**Superfund Five Year Review Report
Benfield Industries Site, Waynesville, NC
EPA ID: NC981026479**

**FINAL SUPERFUND FIVE YEAR REVIEW REPORT
BENFIELD INDUSTRIES SITE
EPA ID: NC981026479**

August 2003

Figure 5. Groundwater Conc.-BaP

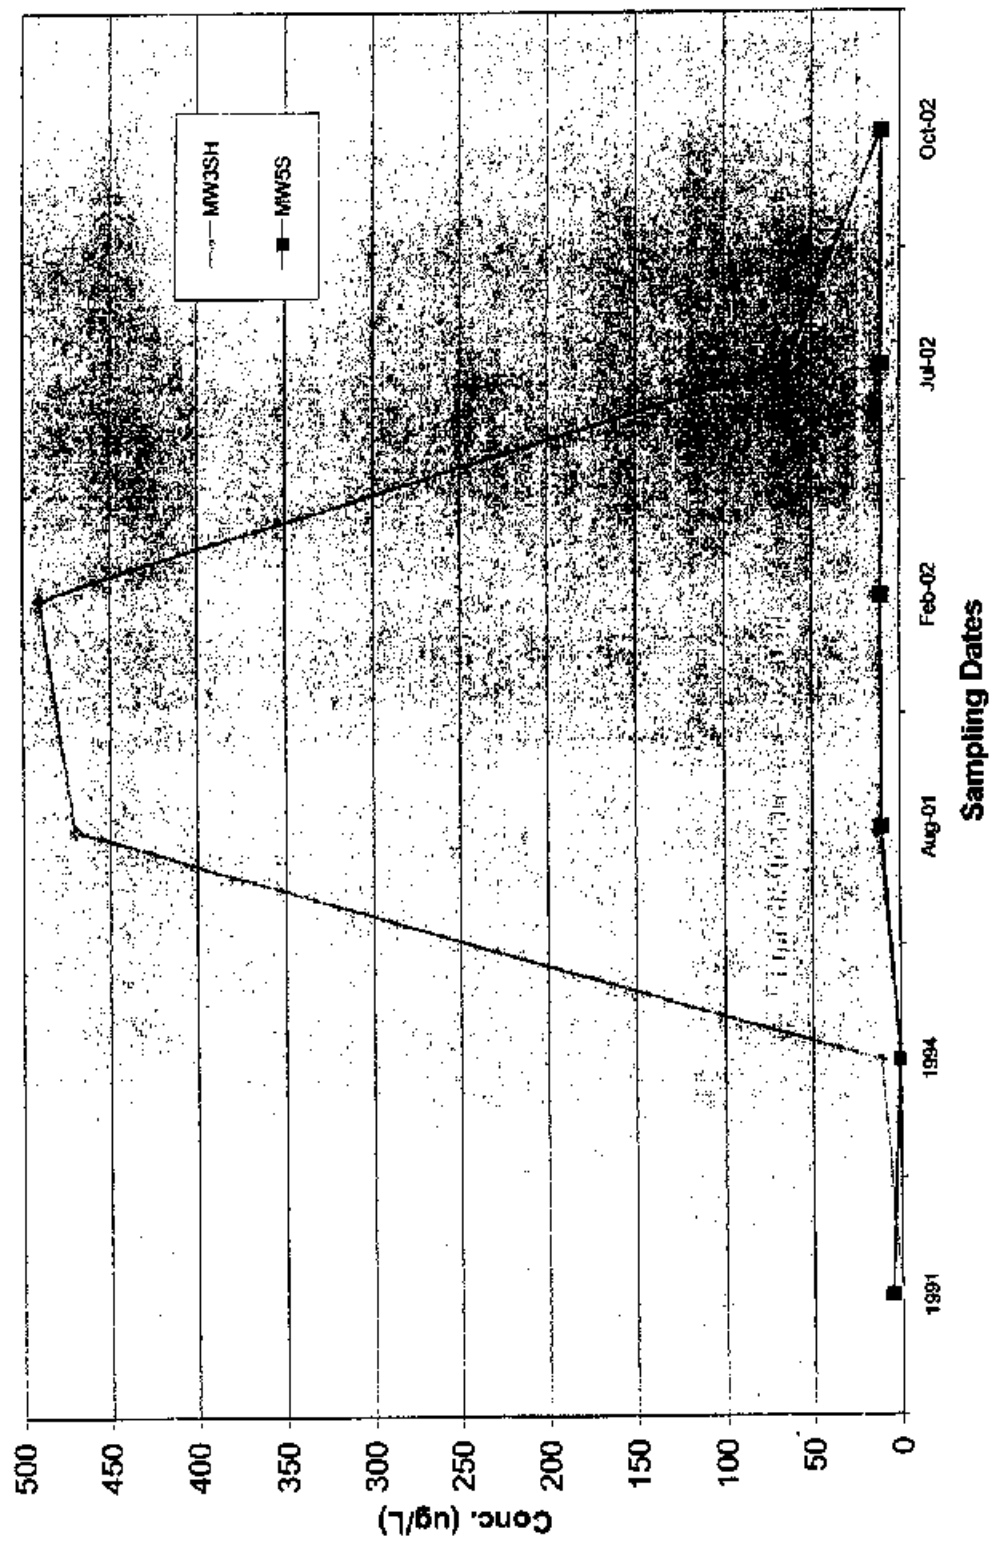
In general, **Figures 3 through 8** show that concentrations of these "risk drivers" has decreased in all wells since Site remediation in 1994. However, BaP concentrations (**Figure 5**) appear to have increased above the remediation level (0.2 ug/L) between 1994 and July 2002 before decreasing again in October 2002. In addition, Mn (**Figure 8**) appears to be on the increase in all three of these wells since August 2002. In the most recent sampling event (October 2002), concentrations of these contaminants were below remediation levels ("RL" on plots), with the exception of Mn in all three wells. The reduction of metal concentrations could be a direct result in a change in sampling technique. A bailer was utilized to collect samples prior to October 2002. For the October 2002 and for all subsequent sampling events a low flow sampling technique was used. This technique usually produces samples with lower turbidity and thus could be responsible for the lower metals concentrations.

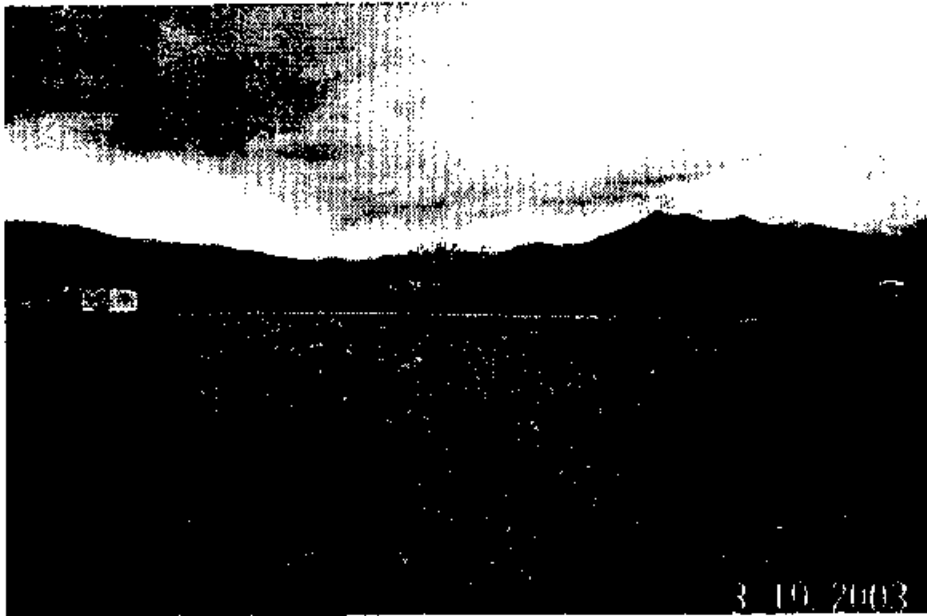
Photograph 4 – Piezometer PZ05A with residence along Riverbend Street in the background. This piezometer is locked, but piezometers and wells at the site were not.
